**RAWHIDE WASH
(AT SILVERSTONE)
SCOTTSDALE, ARIZONA**

**LETTER OF MAP REVISION
TECHNICAL DATA NOTEBOOK**

March 2013
Updated September 2013
Comment Response May, 2014
WP# 113671.02

Subject: FEMA letter dated November 20, 2013
Identifier: Silverstone Rawhide Wash LOMR
FIRM Panel: 04013C1310L
WP #113671.02

Rawhide Wash_Silverstone LOMR AsBuilts Plan: Post-Project 3/26/2014

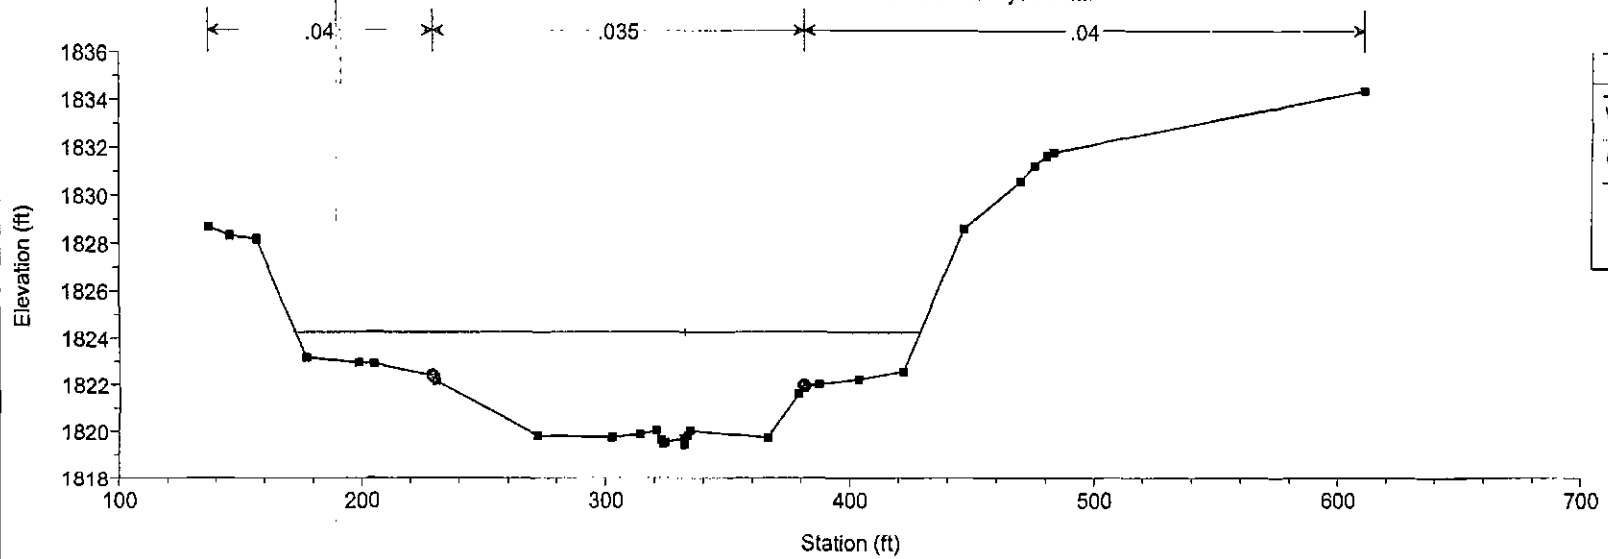
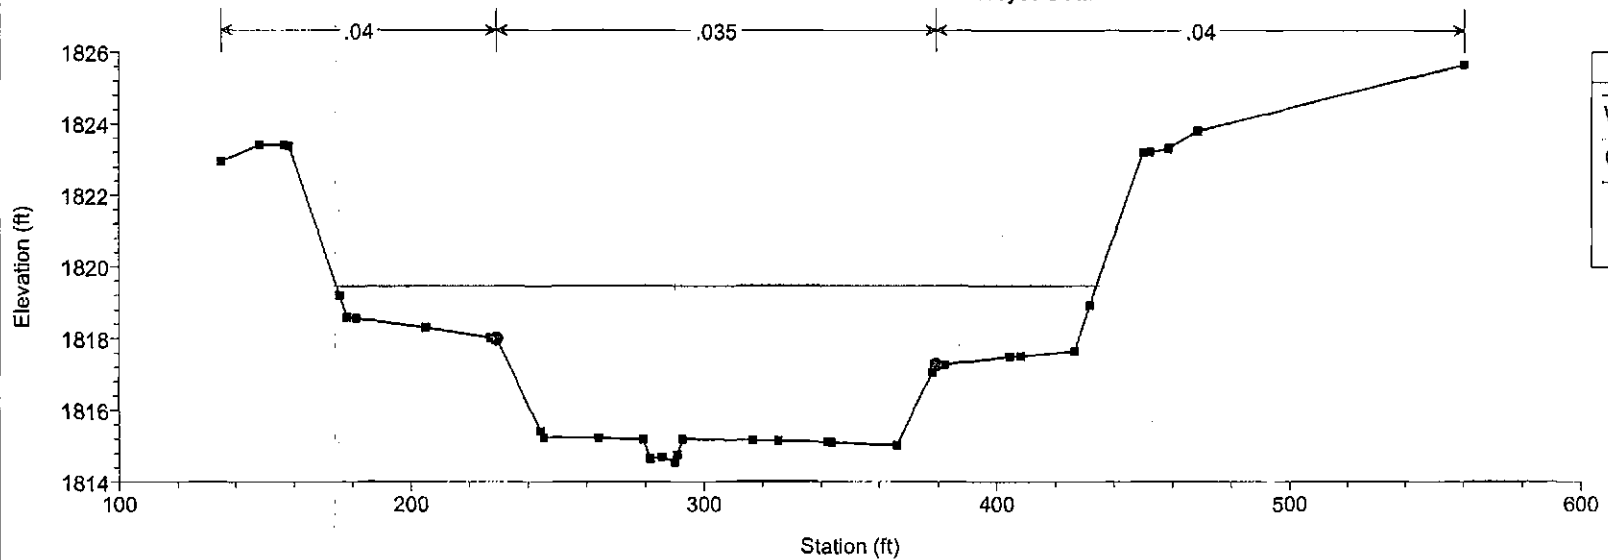
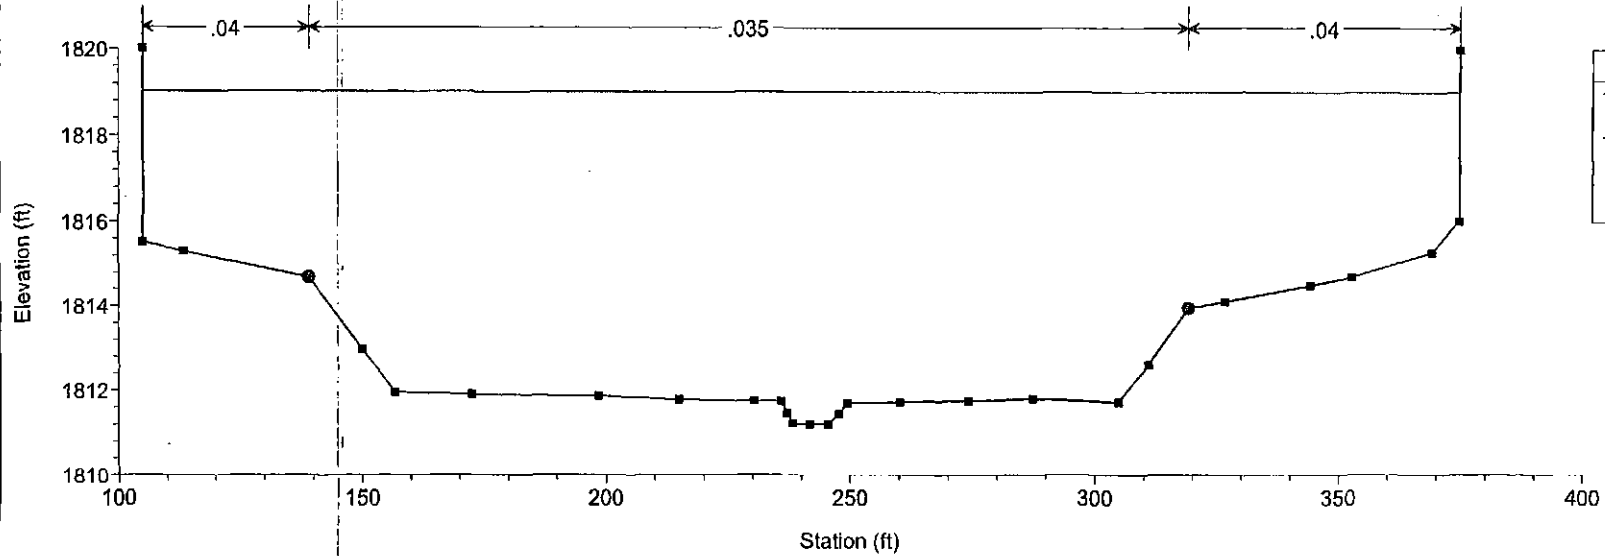
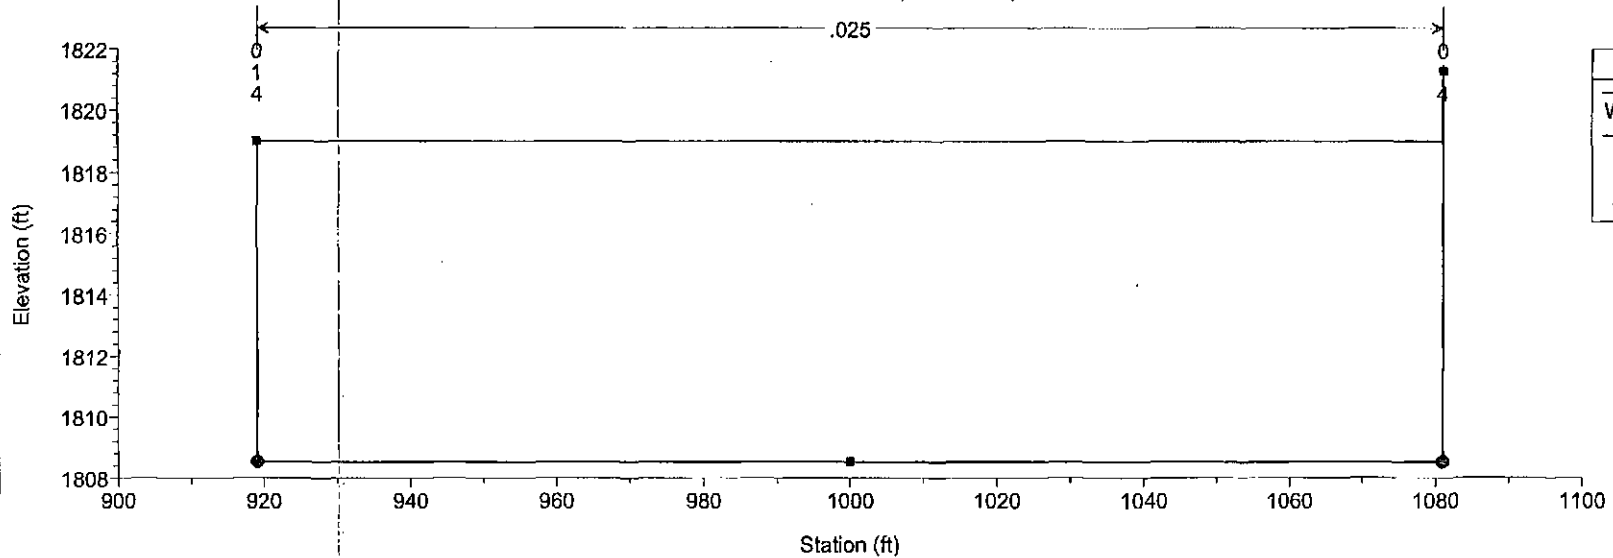
It has come to our attention that the reach of the Unnamed Stream (Rawhide Wash) downstream of East Pinnacle Peak Road has been recently or is currently being modified by channelization since the initiation of this LOMR. Please submit as-built conditions survey or as-built plans, certified by a registered professional engineer, for the channel south of East Pinnacle Peak Road and any other newly constructed structures. Please also provide updated hydraulic modeling and mapping that incorporate the effects of the channel.

1. The as-built topography for the Rawhide Wash from Pinnacle Peak Bridge to the Scottsdale Road Bridge has been included within the HEC-RAS model from Cross Section (C.S.) 2321 through C.S. 3811.
2. The as-built conditions for the Scottsdale Road Bridge have been included within the HEC-RAS model between C.S. 2154 and C.S. 2321.
3. The as-built topography for the daylight channel downstream of the Scottsdale Road Bridge has been included within the HEC-RAS model at C.S. 1990, C.S. 2134 and C.S. 2154.
4. As a result of hydraulically modeling the Scottsdale Road Bridge and the downstream outlet channel, it was necessary to include an additional HEC-RAS cross section (C.S. 1889) to adequately model the overbank flow.

The name of the updated HEC-RAS model is RW_SilverstoneLOMR_Asb.prj. The results of the HEC-RAS model have been displayed on the updated Rawhide Wash (At Silverstone) Letter of Map Revision (LOMR) Technical Data Notebook (TDN) Exhibit 3 Sheet 1 of 2 Rawhide Wash Workmap.

Response: Please note that the construction of the flood control channel serving the Unnamed Stream (Rawhide Wash) was very recently completed. As-built elevations were obtained and certified by a registered professional engineer for the Rawhide Channel Plan (south of Pinnacle Peak Road and east of Scottsdale Road) and the certified as-built Rawhide Wash Channel Plan is included with this submittal. Also included is the updated hydraulic analysis (HEC-RAS analysis) which includes the newly built channel in place, as well as updated work maps.

Detailed Hydraulic Cross-Sections: Plate 1, Sections H, I, J, K

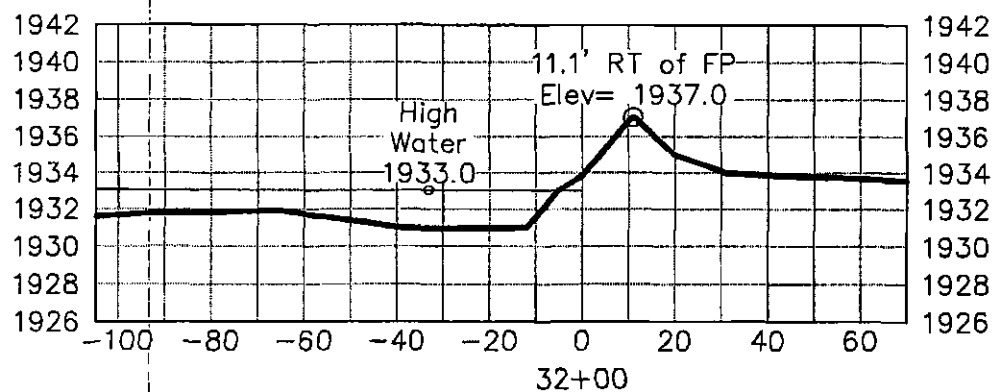
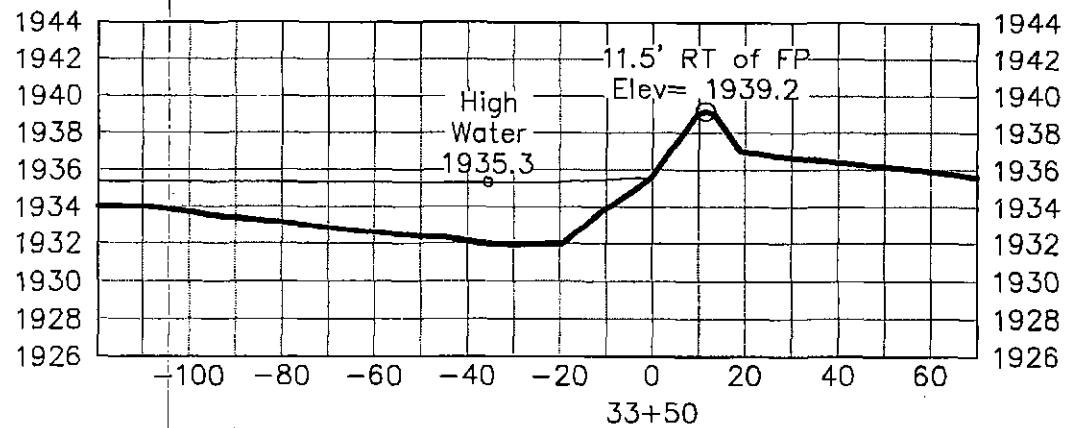
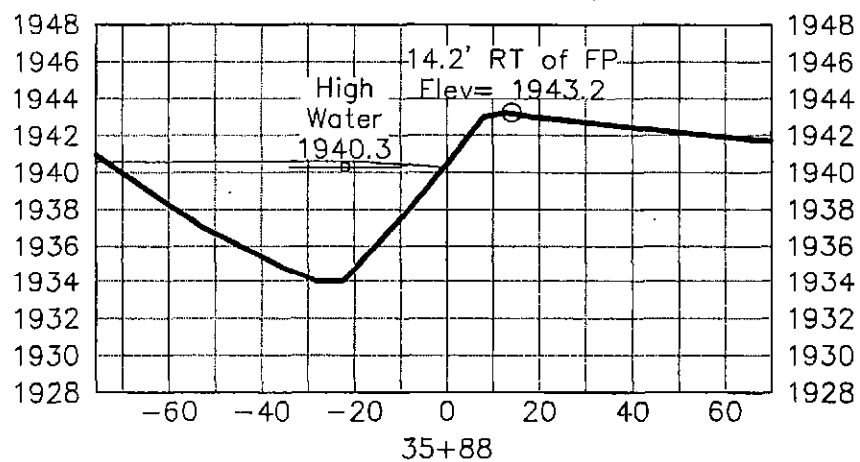
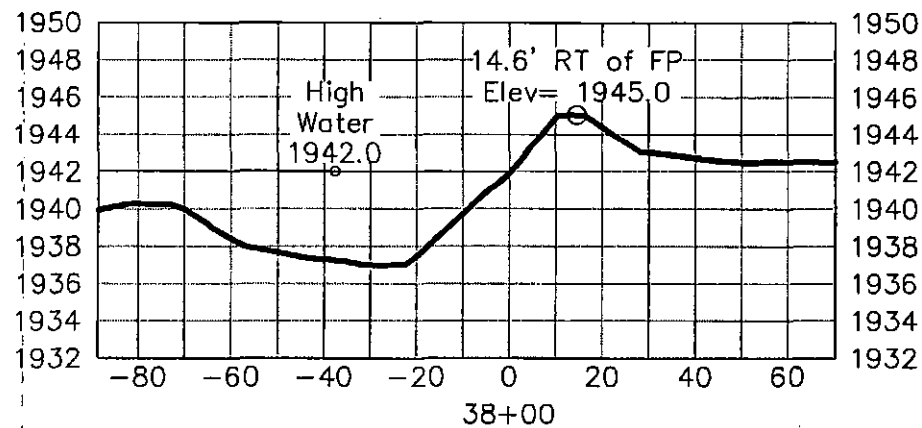
Please submit additional documentation that shows that there are no floodwalls or levee situations on the banks of the Unnamed Wash between East Pinnacle Peak Road and East Happy Valley Road. In addition, please provide certification by a registered professional engineer, certifying that no floodwalls or levee situations were incorporated into the hydraulic analysis. If floodwalls or levee situations do

exist, please state that they do not come in contact with the base (1-percent-annual-chance) flood or provide evidence that the project meets all parts of Section 65.10 of the NFIP regulations.

Response: We contacted Baker/AECOM's Lakewood office to clarify their second comment. From follow up conversations with the reviewer, we learned this comment is applied to the land features on the east side of Rawhide Wash, approximately 2,500 feet north of Pinnacle Peak Road (Area #1) and a specific location (Area #2) along Miller Road, 1,300 feet north of Pinnacle Peak Road. The following research and information documents that no floodwall or levee situation is incorporated into the hydraulic analysis. Results of the analyzed flow indicate containment occurs within the drainage corridor as depicted on the referenced Exhibit 3.

For location, see Work Map Exhibit 3, Sheet 2, Cross-Section 7490

Detailed Hydraulic Cross-Sections: Plate 1, Section H, I, J, K.
